MEMORANDUM

TO: Cassie Younger, Maverik, Inc.
FROM: Stacey Nerger, Senior Planner
DATE: January 3, 2022
SUBJECT: SP21-133 Lincoln Professional Park Filing No. 1 Lot 1 Site Plan

MAVERIK INC. STORE
 LINCOLN AVE. AND DRANSFELDT RD.
 PARKER, CO

SITE PLAN

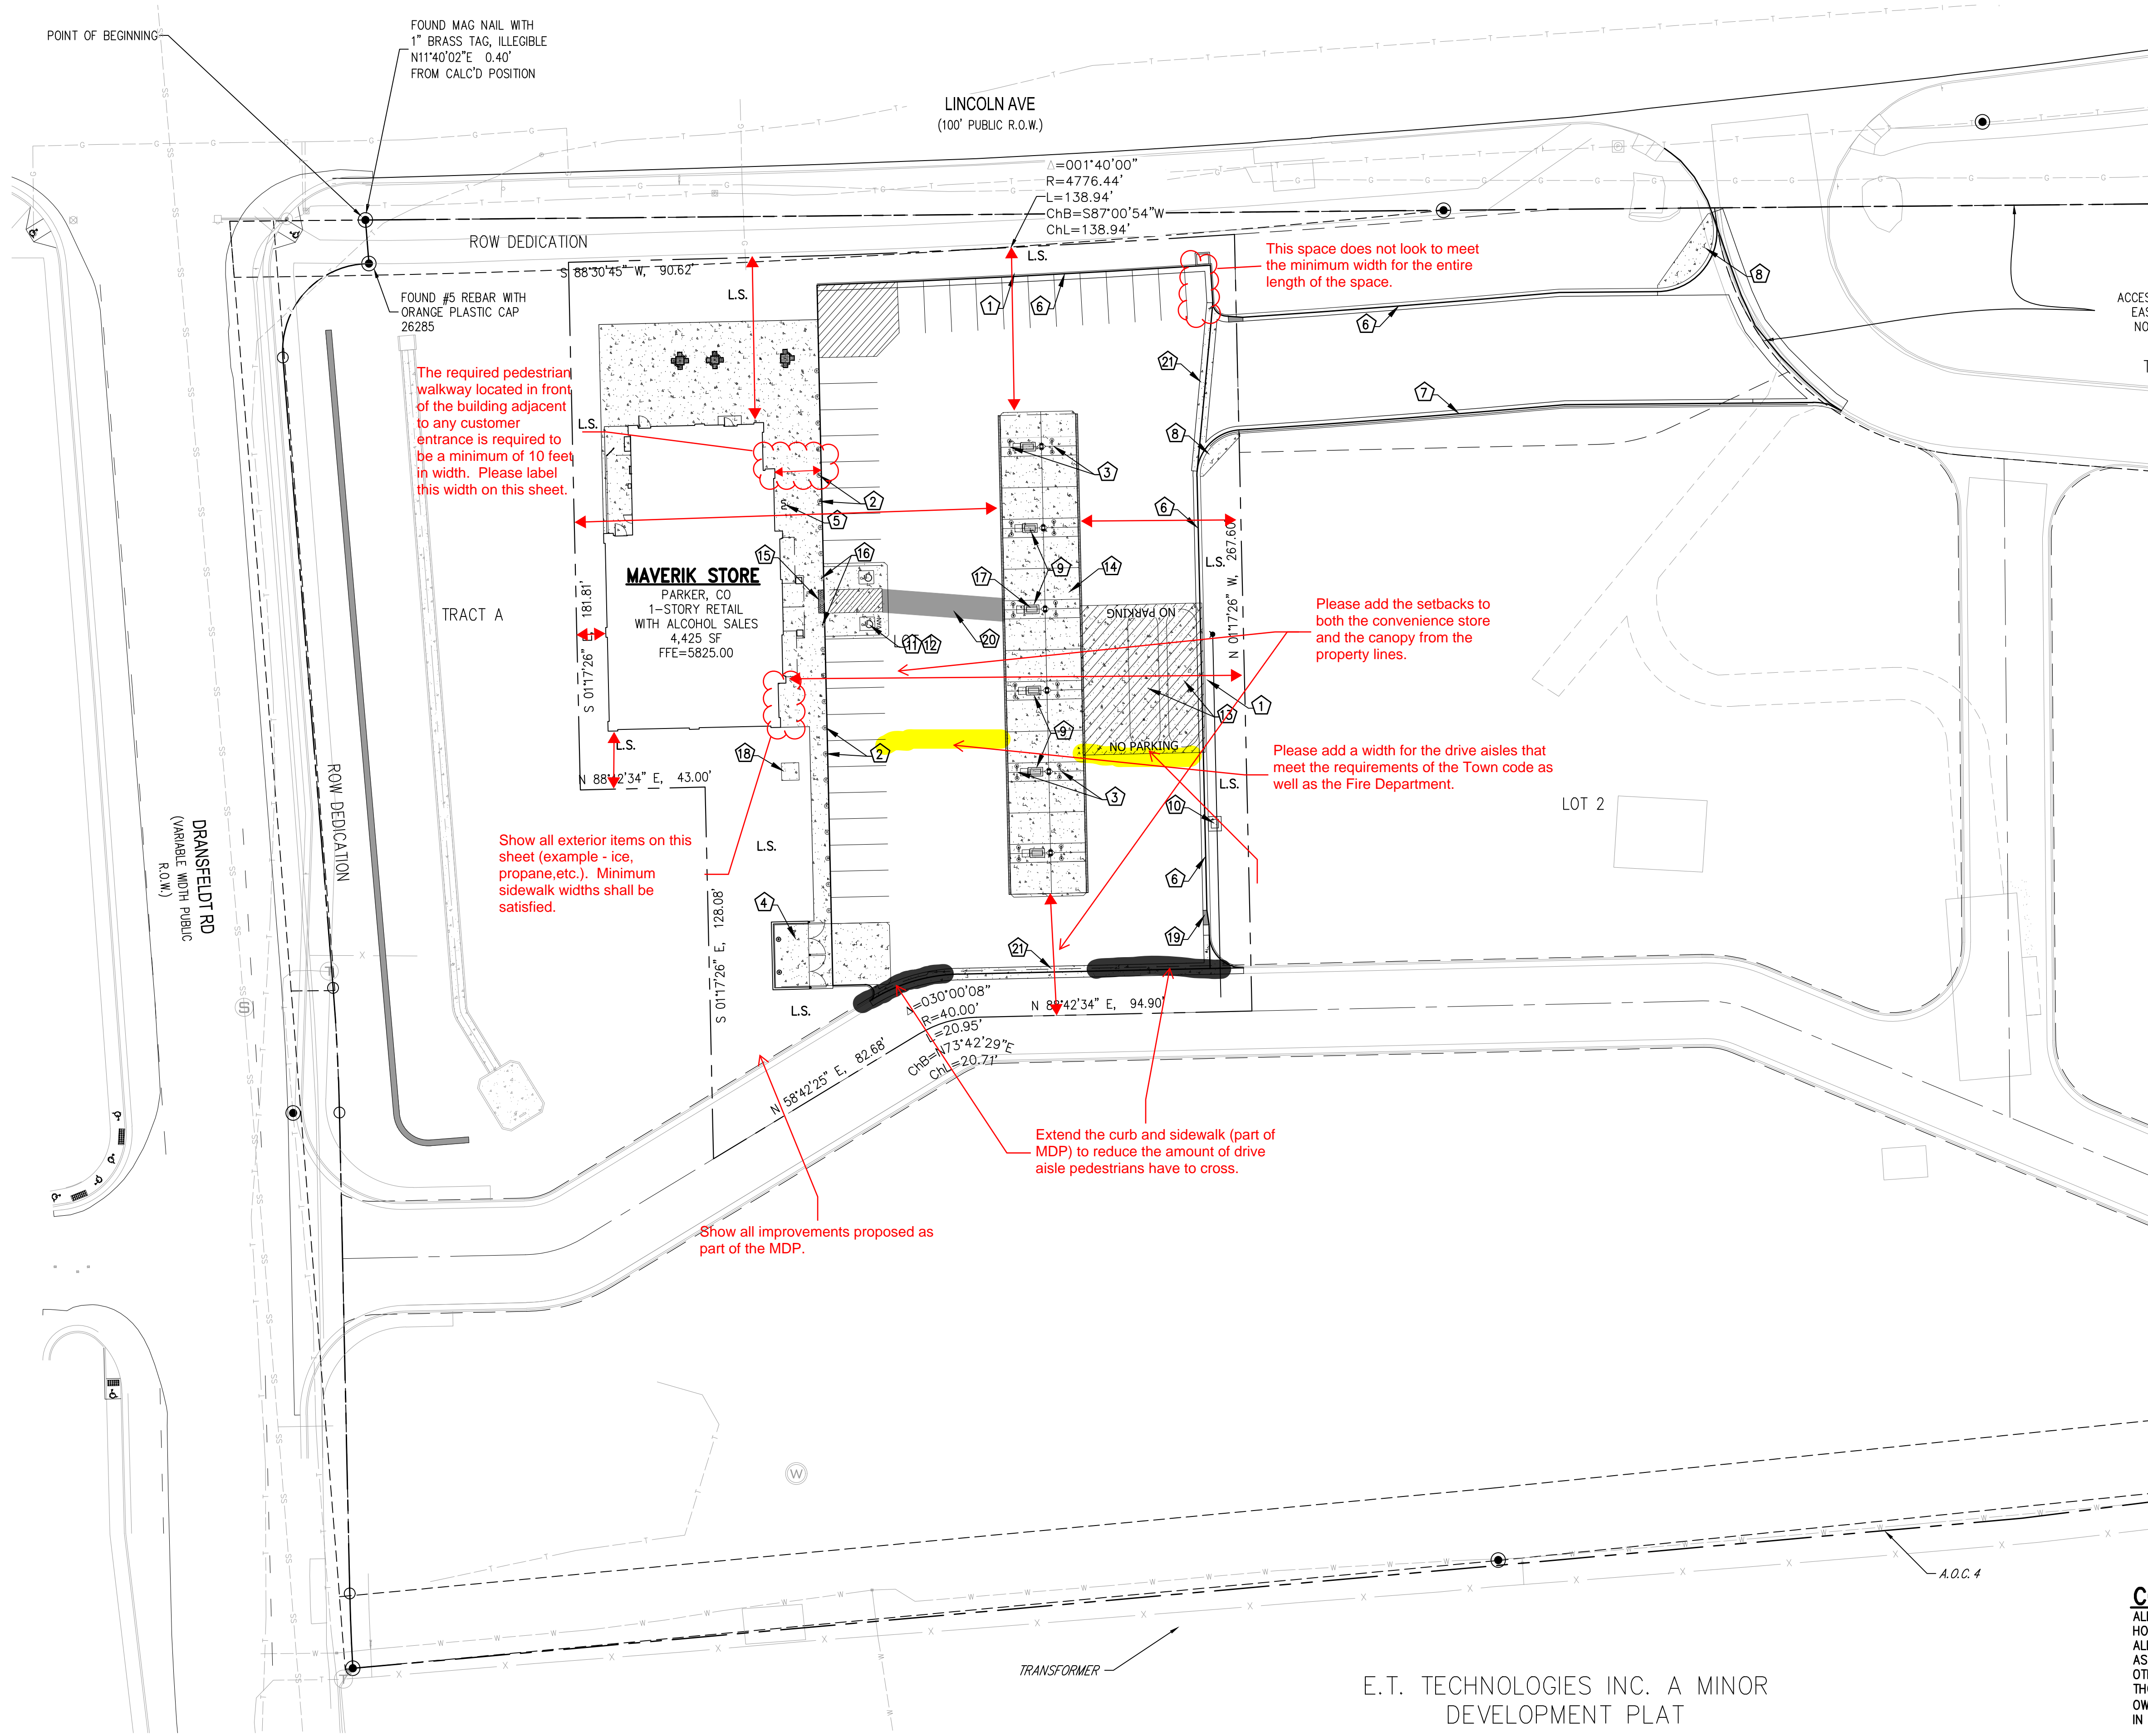
Please add a title to all pages of the Site Plan package. The title should be:
**Lincoln Professional Park Filing No. 1 Lot 1
 Site Plan - Maverik**

All items circled need to be included in the site plan set. Images along with colors need to be included.

These notes do not align with sheet numbers, please amend.

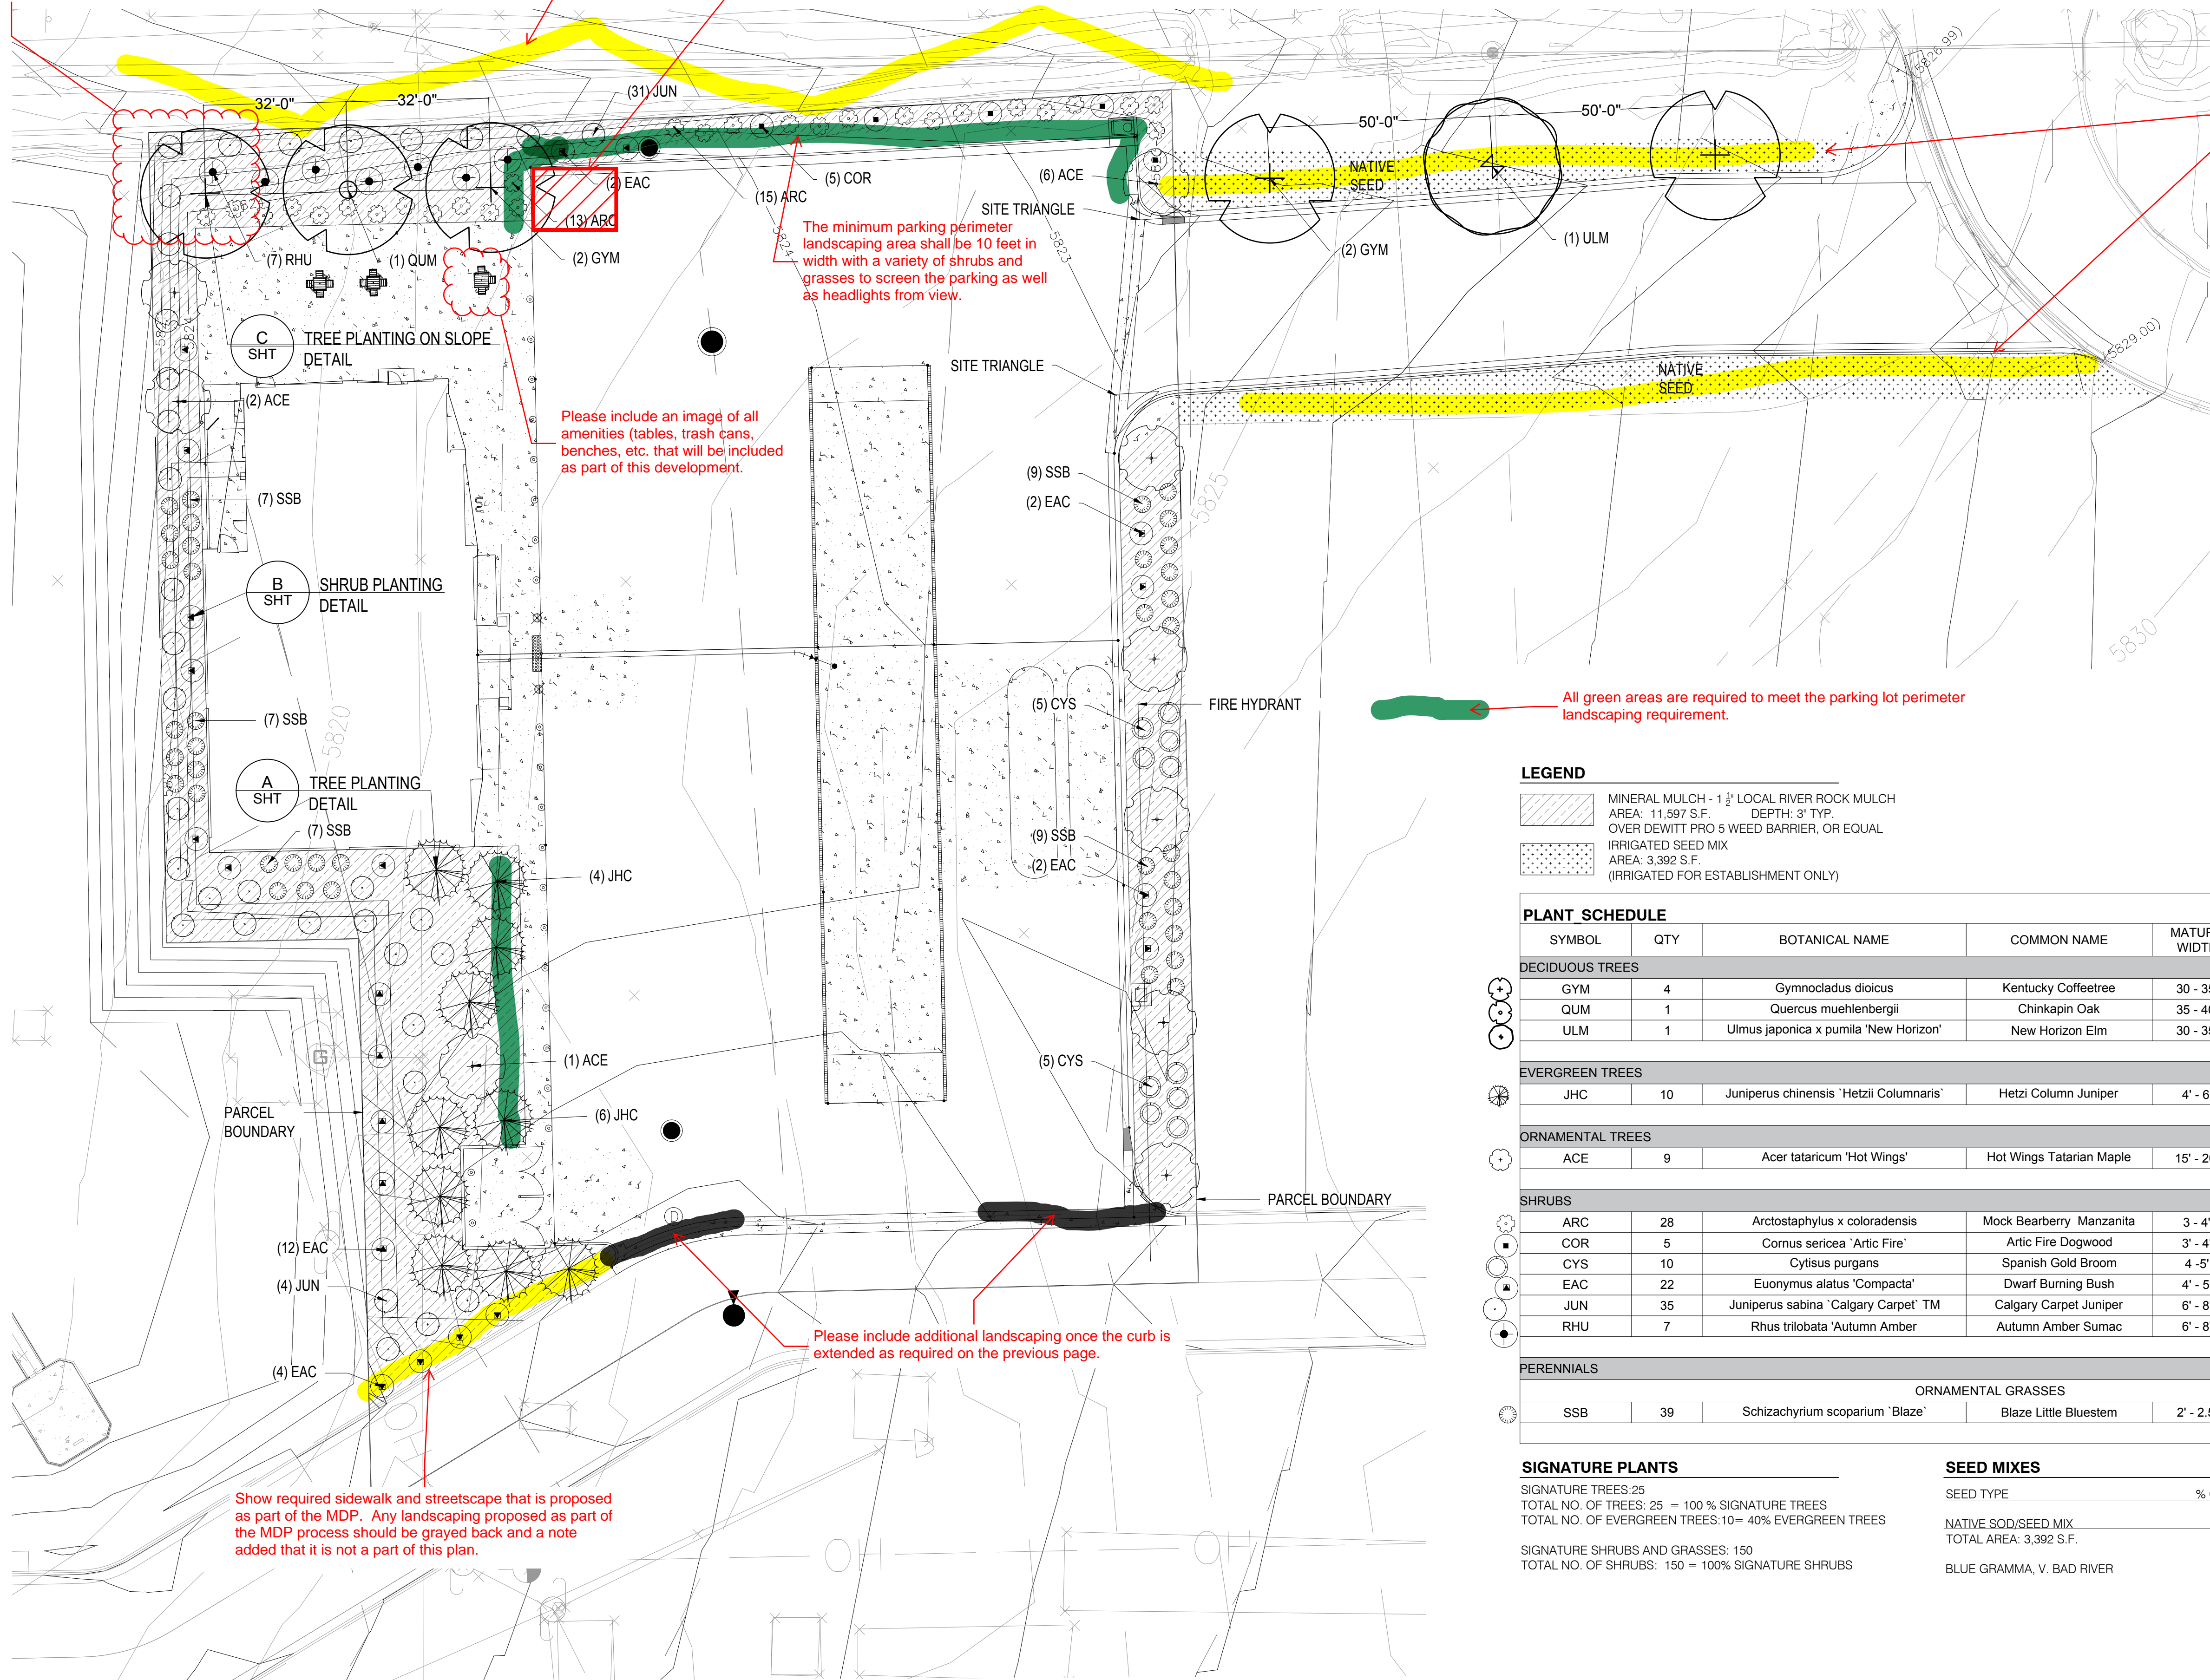
See Planning Memo for corner landscape feature requirement.

Landscaping to Lincoln Avenue should be shown. Even if not part of this application.

Since this area is proposed to be striped, please add landscaping to help meet the intent of breaking up parking areas.

The minimum parking perimeter landscaping area shall be 10 feet in width with a variety of shrubs and grasses to screen the parking as well as headlights from view.

Please include an image of all amenities (tables, trash cans, benches, etc. that will be included as part of this development.

Landscaping within this area should be a part of the MDP and not part of this application. All sidewalk should also be shown.

All green areas are required to meet the parking lot perimeter landscaping requirement.

Please include additional landscaping once the curb is extended as required on the previous page.

Show required sidewalk and streetscape that is proposed as part of the MDP. Any landscaping proposed as part of the MDP process should be grayed back and a note added that it is not a part of this plan.
